RE: JMC Project 19141
 One Kent Place Inc.
 1 Kent Place
 Town of North Castle, NY

Response to Memorandums

<u>Dwg.</u>	<u>Title</u>	<u>Rev. #/Date</u>	
S-1	“Site Plan”	4	11/22/2021
WMP-1	“Wetland Mitigation Plan”	2	11/22/2021

Drawn: DK Approved: JAR
 Scale: 1" = 10"
 Date: 11/09/2020
 Project No: 19141
 1941-SITE SITE --SPT
 Drawing No: S-1

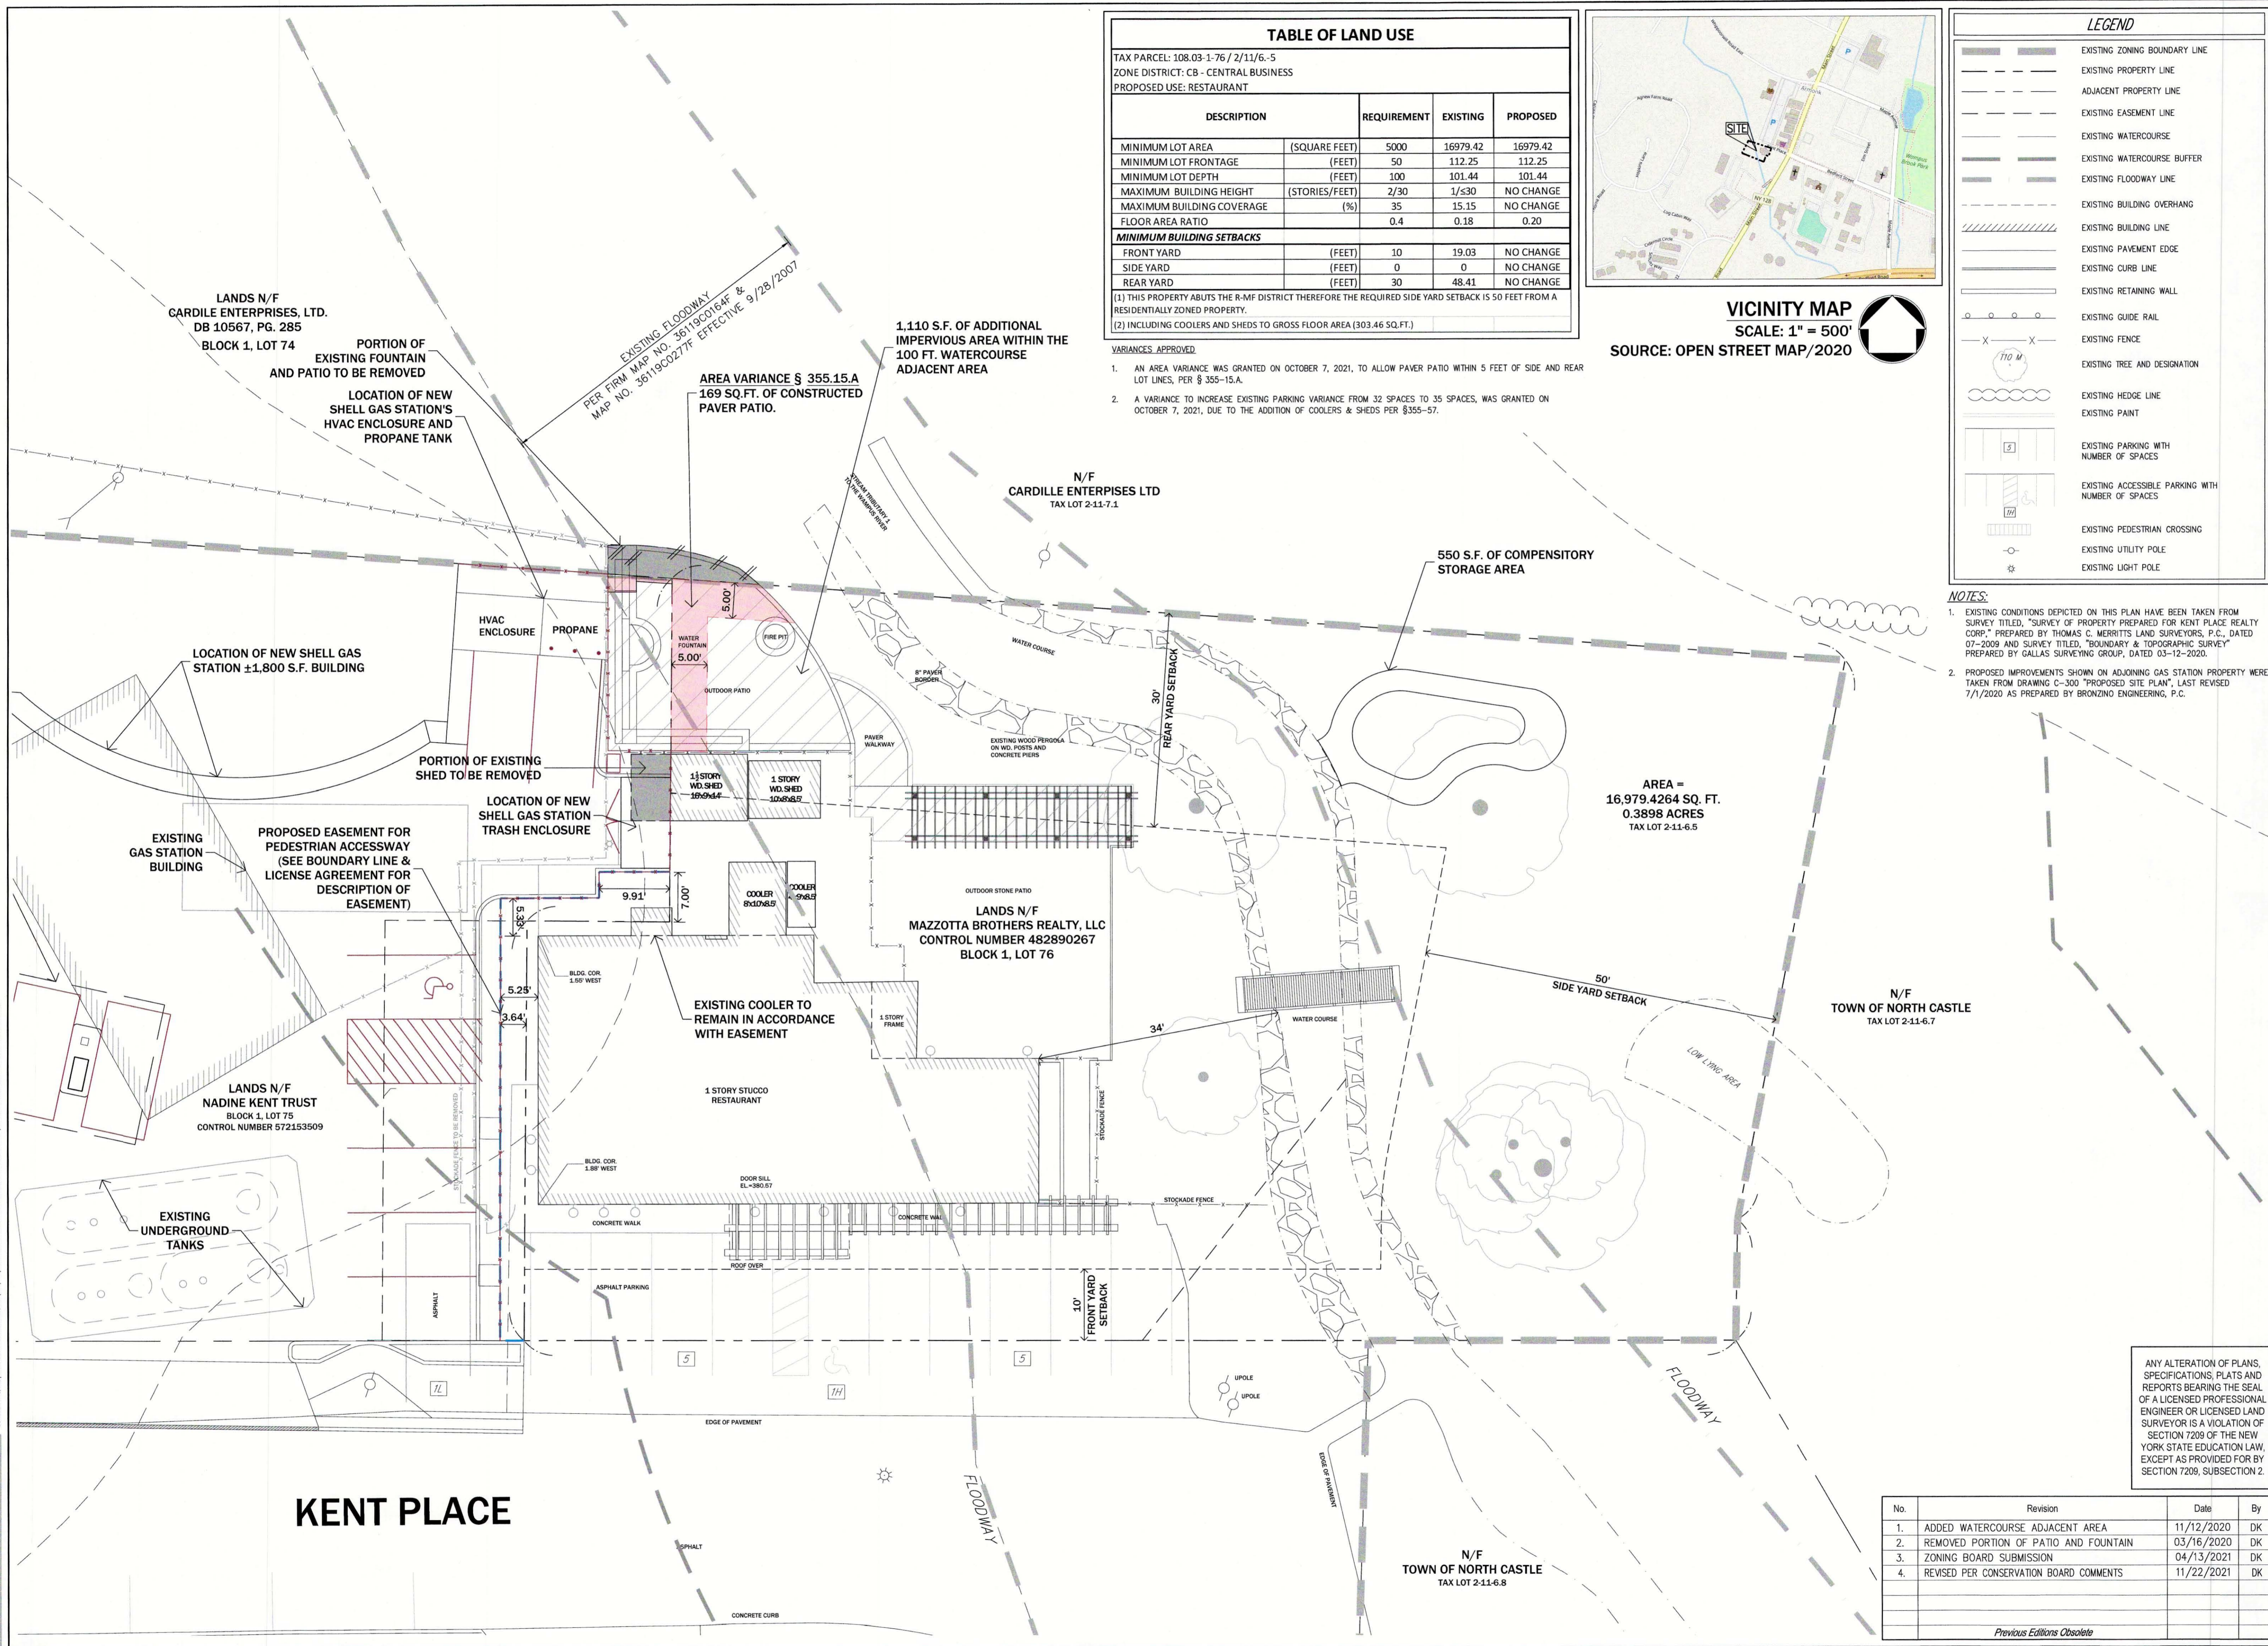
The plan proposes to maintain an existing cooler, constructed at the rear of the restaurant building, which encroaches onto the adjacent property. This will result in a zero lot line set back. It appears an area variance will be required. This should be verified by the Building Department.

The applicant will be required to provide appropriate stormwater mitigation for the previously completed improvements. A Stormwater Management Design Report and sizing calculations shall be provided for review. Depending upon the need for flood storage mitigation and how that maybe provided by the applicant, it may be more beneficial to provide stormwater quality practices vs. additional detention above what will already be required to mitigate the floodplain development.

Improvements are noted on the JMC Site Plan entitled S-1 "Site Plan", last revised 11/22/2021, which remove the noted encroachment. Variances have been obtained for the various encroachment required by the Building Department.

The comment is so noted. Stormwater management information is provided on the JMC site plan entitled S-1 "Site Plan", last revised 11/22/2021 for the Planning Boards consideration mitigation measures proposed include:

1. Converting outdoor patio area to act as porous pavers by removing the silicon joints, since the pavers where constructed on a gravel base.
2. Providing compensatory storage area and reconstructing a portion of the western stream bank to promote flow into new area.

Drawn: DK Approved: JAR
Scale: 1" = 10'
Date: 11/01/2021
Project No: 19141
1941-02 WETLAND MITIGATION
Drawing No: WMP-1
Previous Editions Obsolete

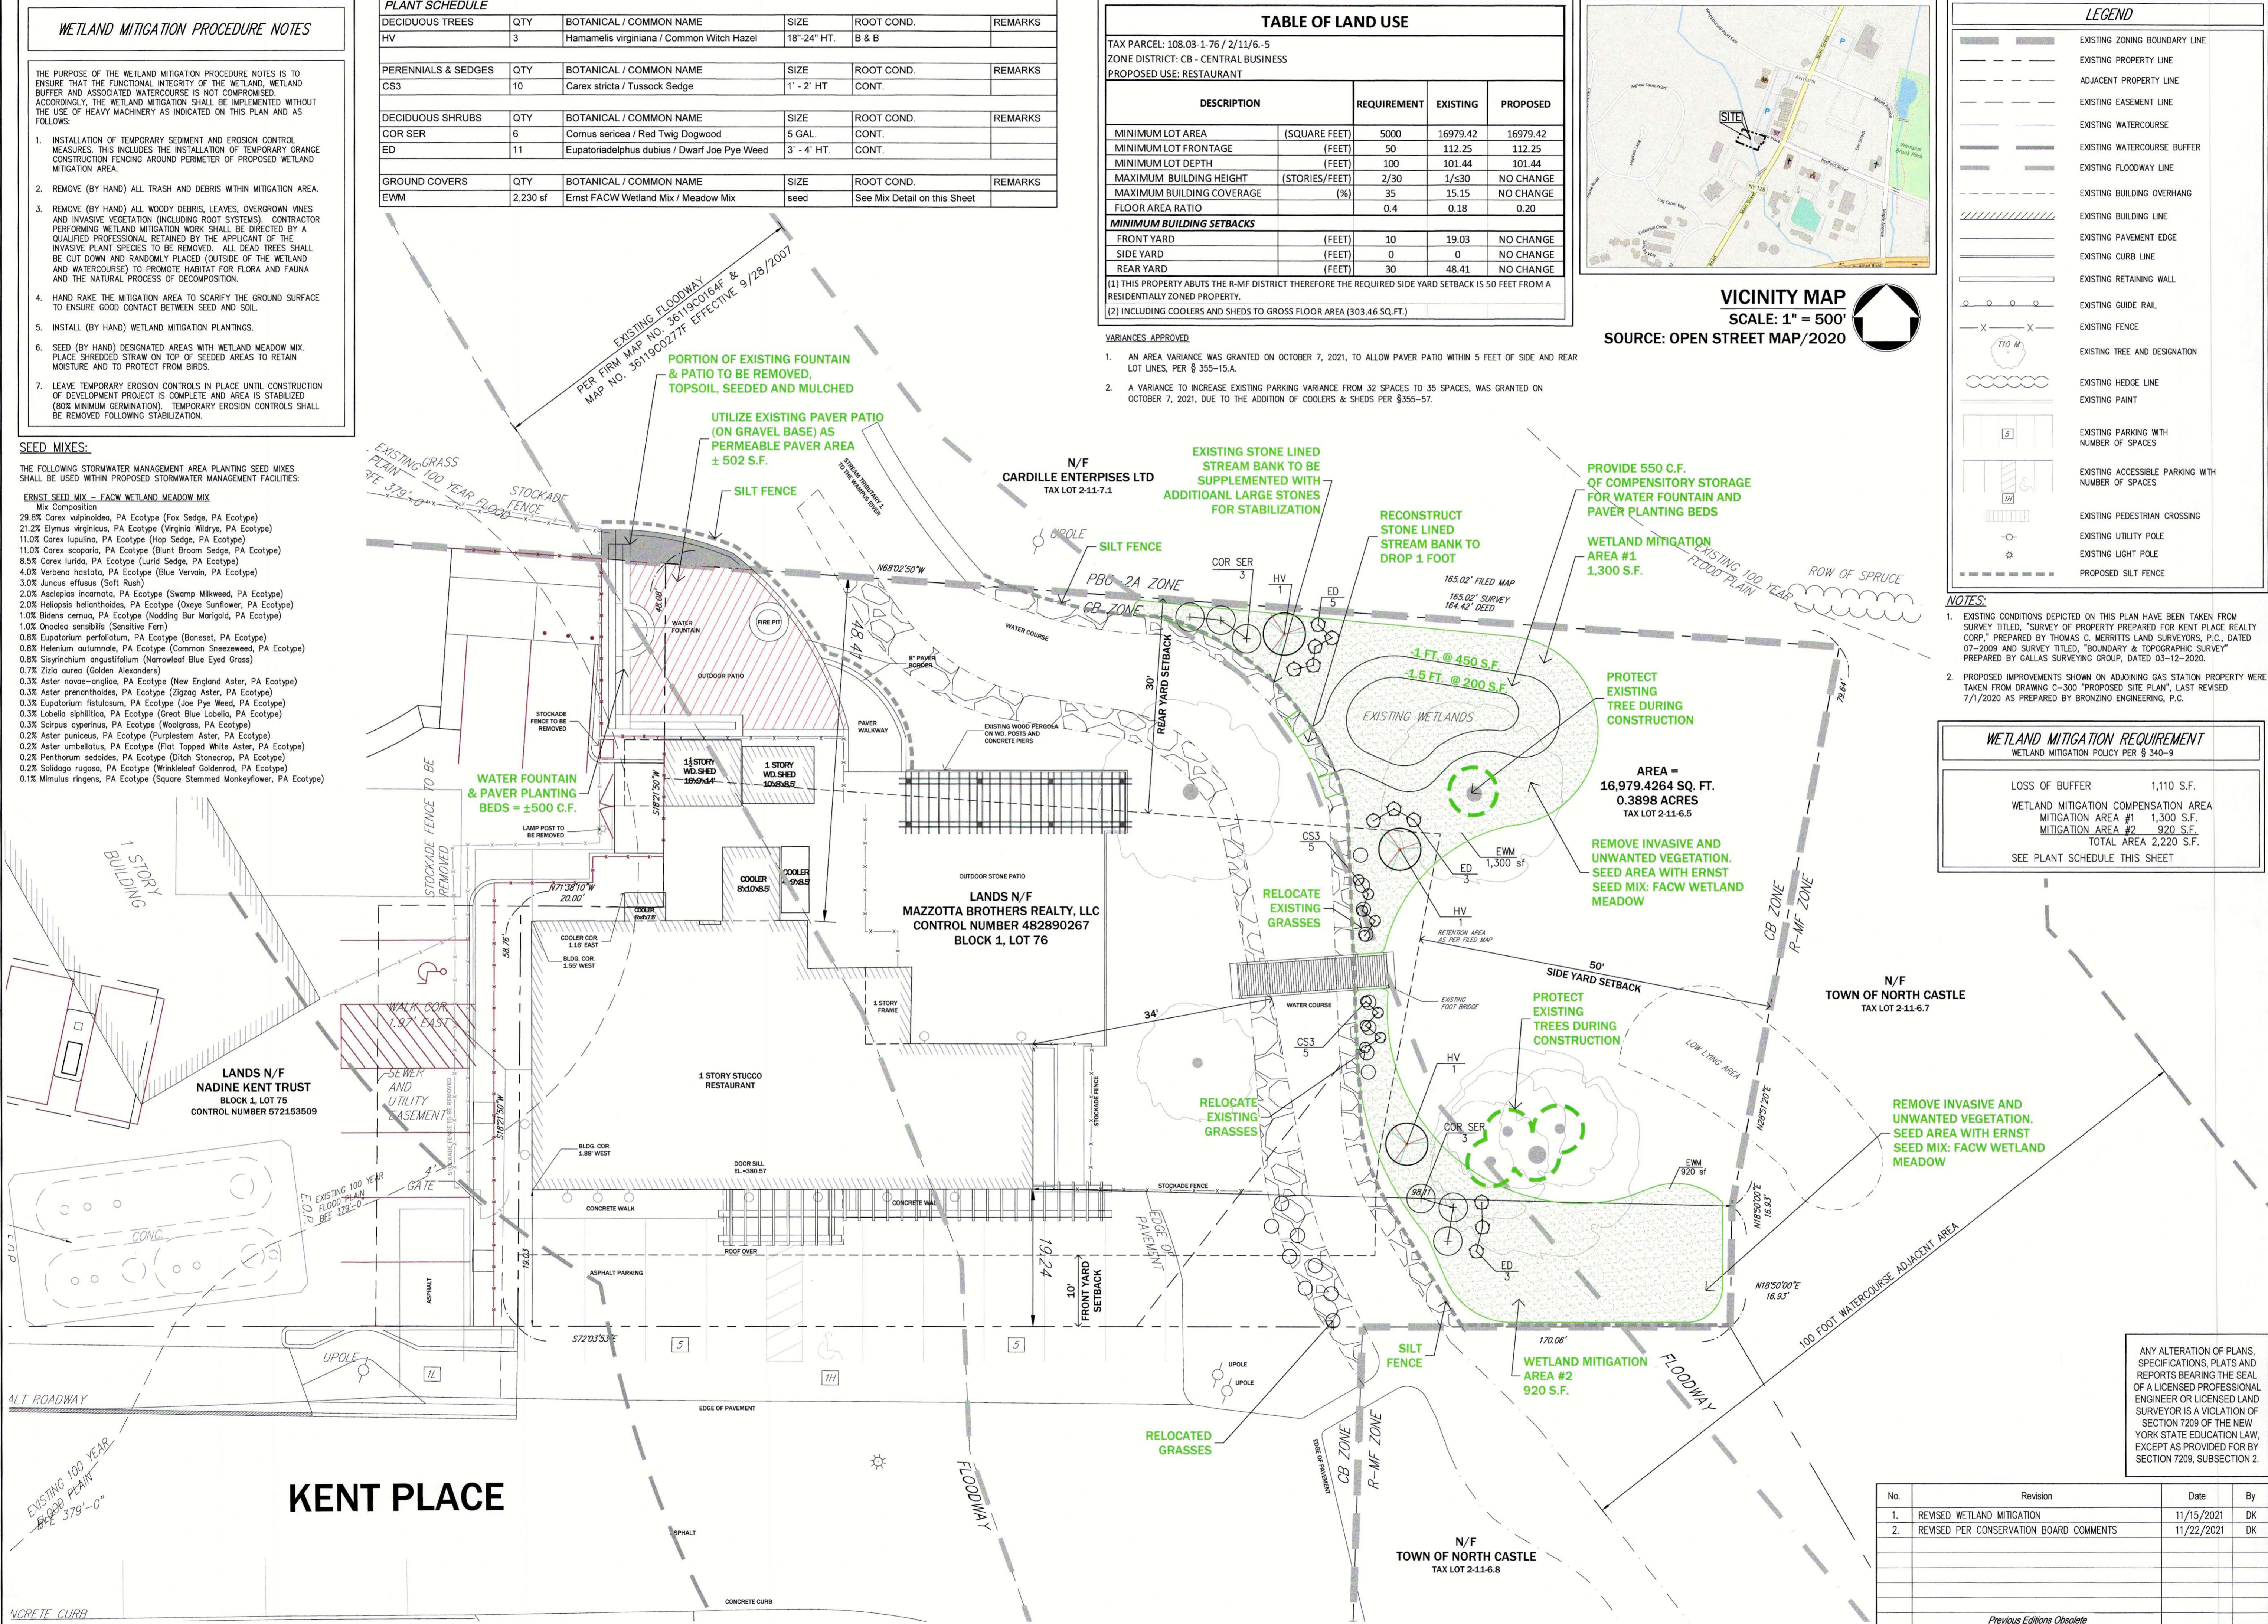
The applicant will be required to provide an erosion and sediment control plan for any improvements that may become necessary. Provide details.

The site plan depicts disturbance within the Town-regulated wetland buffer. The site plan should be revised to depict the location of the wetland and wetland buffer. In addition, the site plan should quantify the proposed amount of Town-regulated wetland buffer disturbance (in sq. ft.). Furthermore, the Applicant is required to prepare a mitigation plan that is twice the area of the proposed wetland buffer disturbance.

The applicant should locate the existing floodway on the map to make sure that there is no encroachment from the new construction (patio).

Compensatory storage should be provided, as needed, to off-set loss of floodplain storage, as a result of the recent construction of all structures, including the patio, planters and walls.

JMC drawing WMP-1 “Wetland Mitigation Plan”, last revised 11/22/2021 indicates the required sediment and erosion control measures as requested.

JMC has prepared a drawing called WMP-I “Wetland Mitigation Plan”, last revised 11/22/2021 which we have included with this submission. The noted plan provides mitigation on a two-to-one basis as required.

The comment is so noted. Existing flood boundaries are now identified on JMC Plan WMP-1 "Wetland Mitigation Plan, last revised 11/22/2021.

Compensatory storage has been provided as indicated on JMC plan WMP-1 entitled “Wetland Mitigation Plan”, last revised 11/22/2021.
